**Bureau of Environmental Health**

RECEIPT DATE: 8/2/18 **ONSITE SEWAGE DISPOSAL SYSTEM**P 563970APPROVAL DATE: 9/17/18 SEC **PERMIT: CONSTRUCTION**

PROPERTY ADDRESS: 1025 Thunderbird DriveSUBDIVISION: Fairlane FarmsLOT: 31 TAX ID: _____CONTRACTOR: South Carroll BackhoeEMAIL: scbackhoe@comcast.comCONTRACTOR ADDRESS: 4410 Salem Bottom Road, Westminster, MD 21157PHONE: 410-596-3618PROPERTY OWNER: NV Homes

SEPTIC SYSTEM
INSTALLATION SITE PLAN
LOT 31
1025 THUNDERBIRD DRIVE
FAIRLANE FARMS
PHASE TWO

VICINITY MAP
SCALE: 1" = 1200'

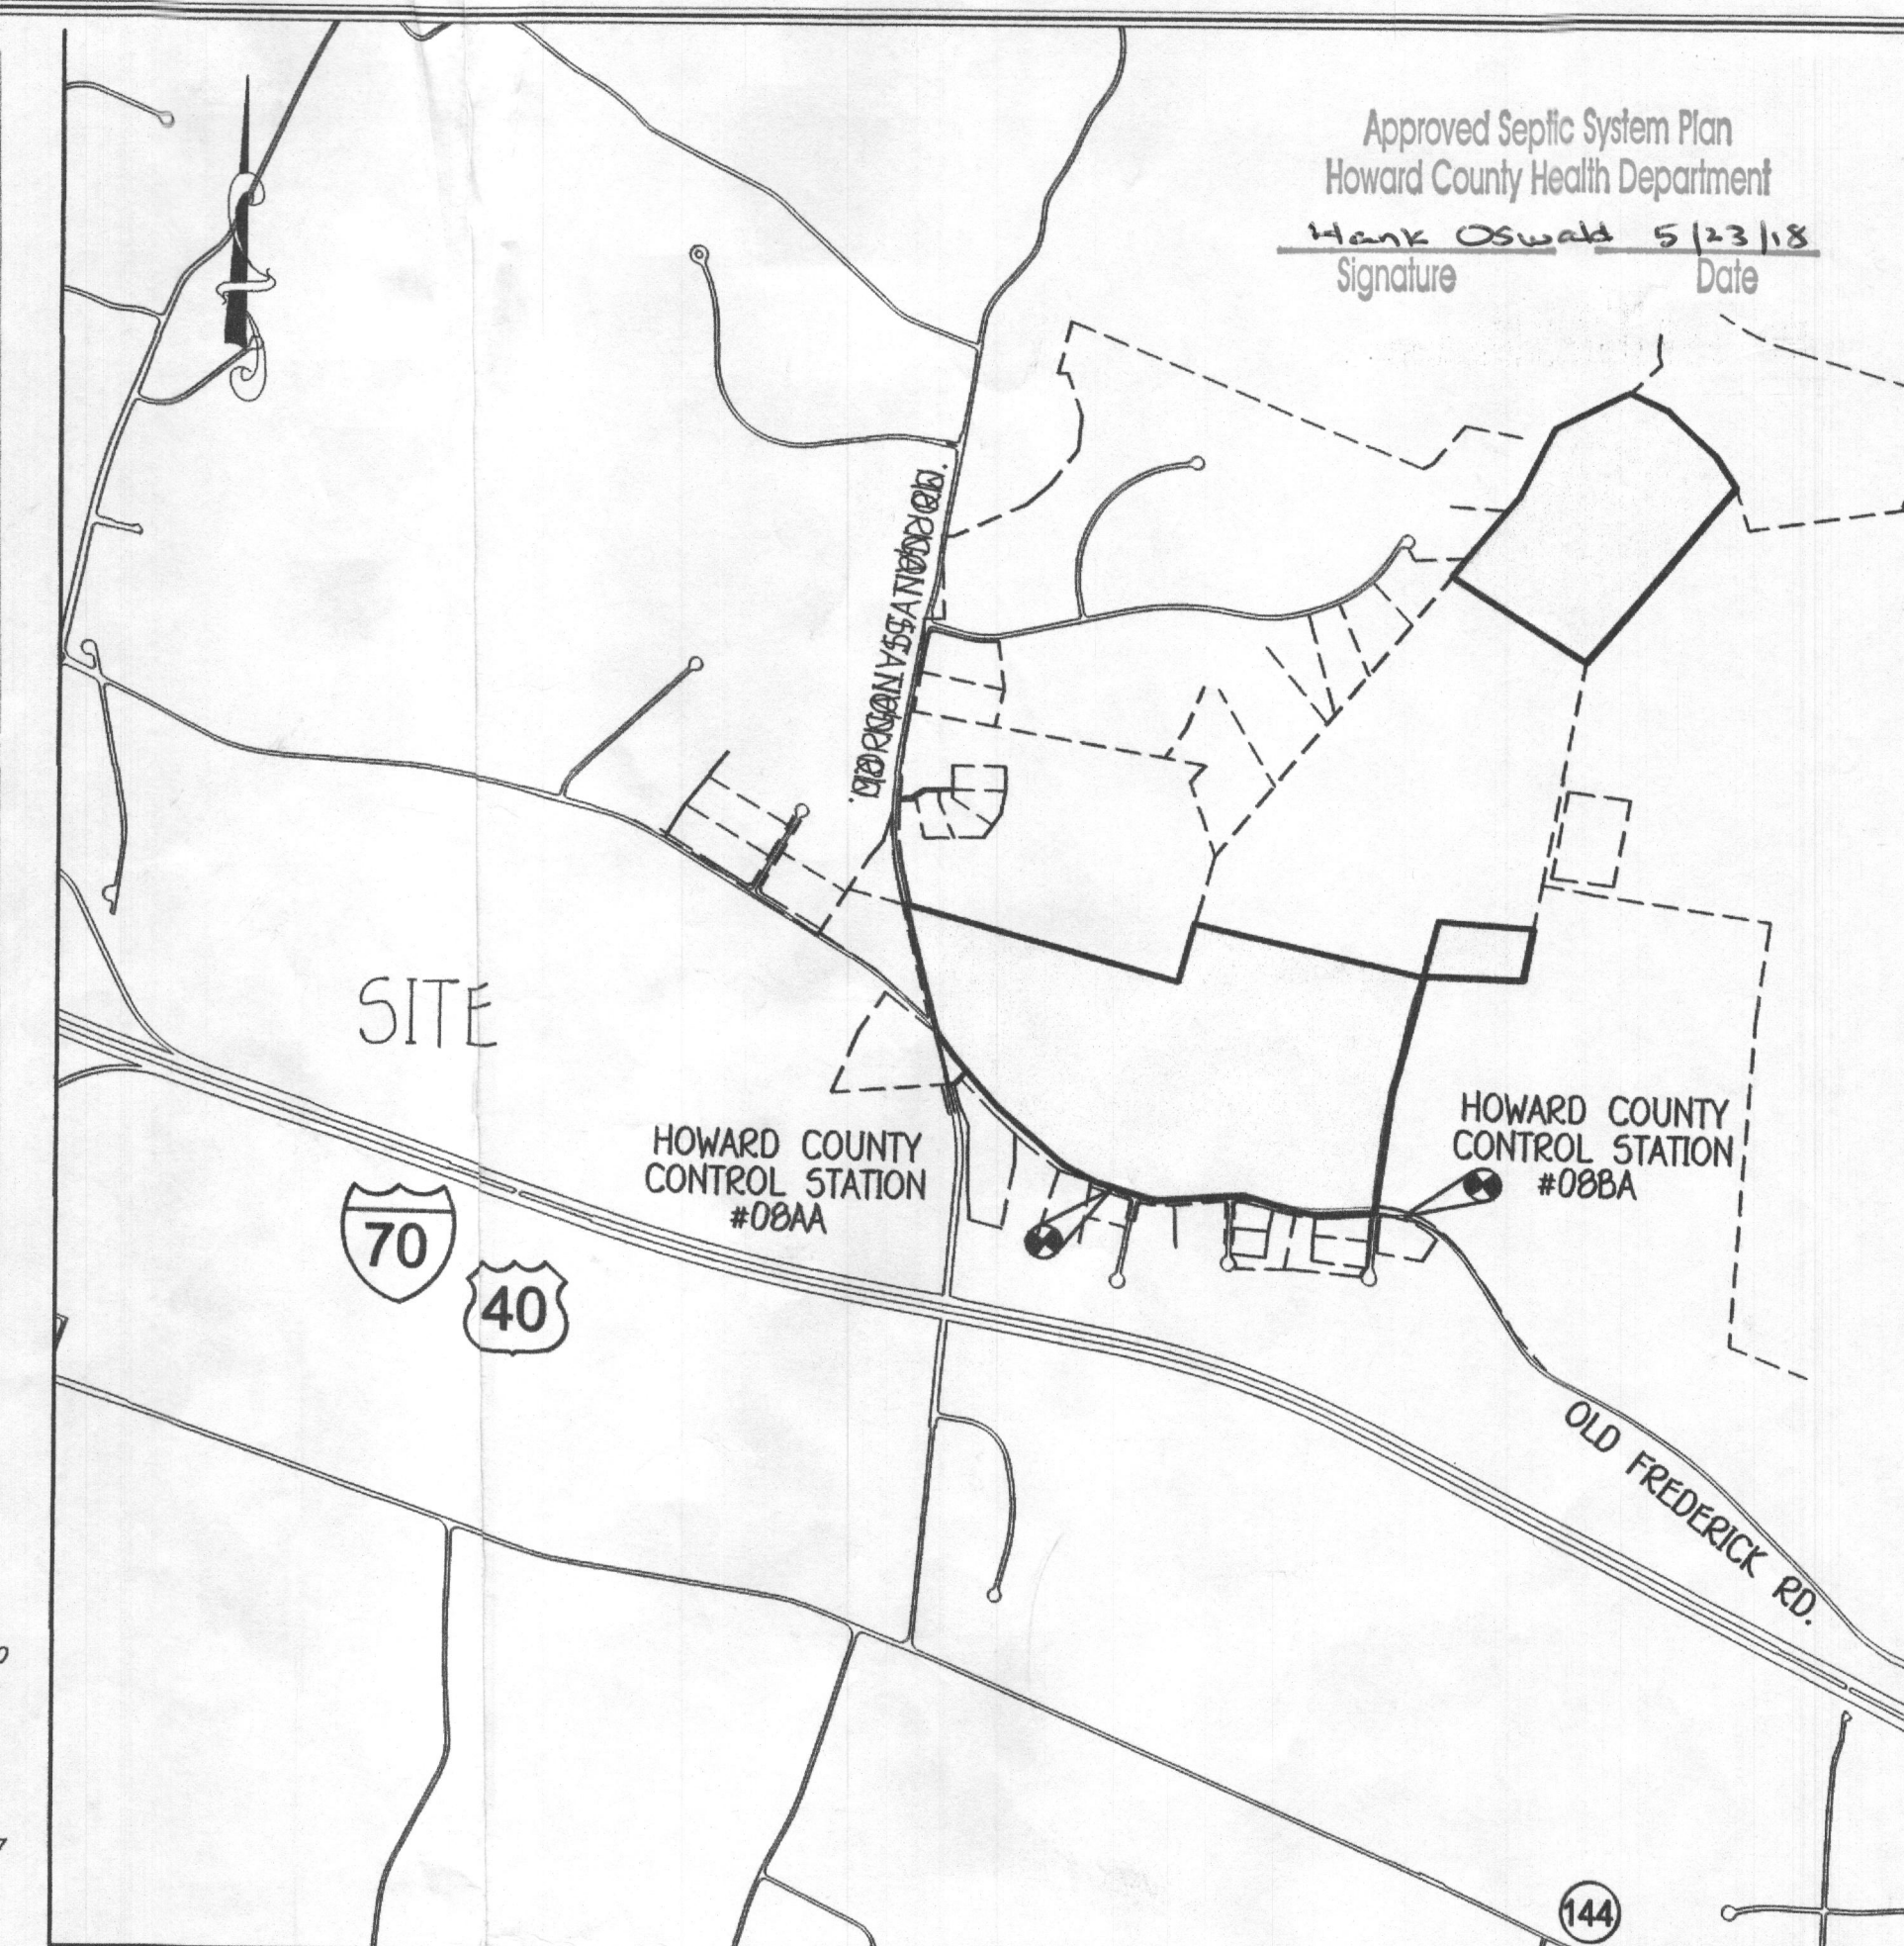
8/27/18 Met S. Carroll on site for layout. SDA corners + tank staked. OK to turn tank 90° to be in line with house sewer. Specs for initial system have a math error on septic plan - can have inlet 3', bottom 7.5', 120' total length. OK to install 2x60' trenches above perc hole #248 and move D-box uphill to start of T1. Shot contour + laid out 2x60' trenches. (SC)

INSTALLATION: 8/29/18 T1 dug, S. Carroll adding stone. 3' wide, 7.5' bottom. Measured inlet @ 4', should be 3'. Trench partially filled w/ stone + pipe, S. Carroll will raise 1'. [Corrective action.] On site while tank was set, no obvious cracks on bottom or sides of tank.

8/30/18 Trenches complete T2 left open for inspection + T1 left open @ ends. 3' wide, 7.5' to stone. [Corrective action completed.] Levelled speed levelers in D-box. Line run from house to tank, need house connection. (SC) 9/17/18 House connection made. Pictures sent from builder. (SC)
